REQUEST – September 9, 2019

(ST1917) Dean DeGraaf, 6680 Marcan, is requesting site plan approval to construct a 21,000 square foot building with four individual units for the use of storage and industrial uses, allowed under Sec.17.2(C) and Sec. 17.2(A), in an (I) Industrial district. P.P. # 70-14-21-441-004, located at 6680 Marcan, Georgetown Township, Ottawa County, Michigan.

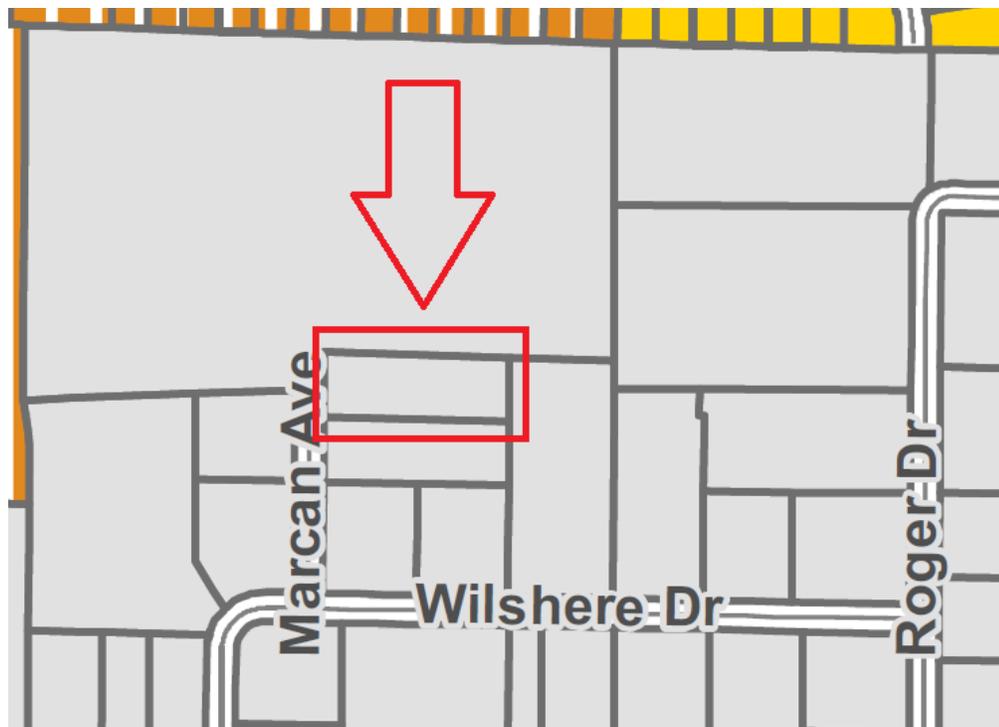
Front – 45 feet from the property line. Footnote (R) is applicable (see below) and requires that the front yard for 30 feet shall be landscaped and not be used for parking. Landscaping shall meet requirements in Sec. 3.11. One tree is required for each 25 foot or fraction thereof of frontage. **The frontage is 146.45/25 = 6; therefore, 6 trees are required. Met.**

Sides – 20 (as long as not adjacent to a residential district). **Met.**

Rear – 20 feet required adjacent to another Industrial parcel, as per footnote (x). **Meets ordinance requirements.**
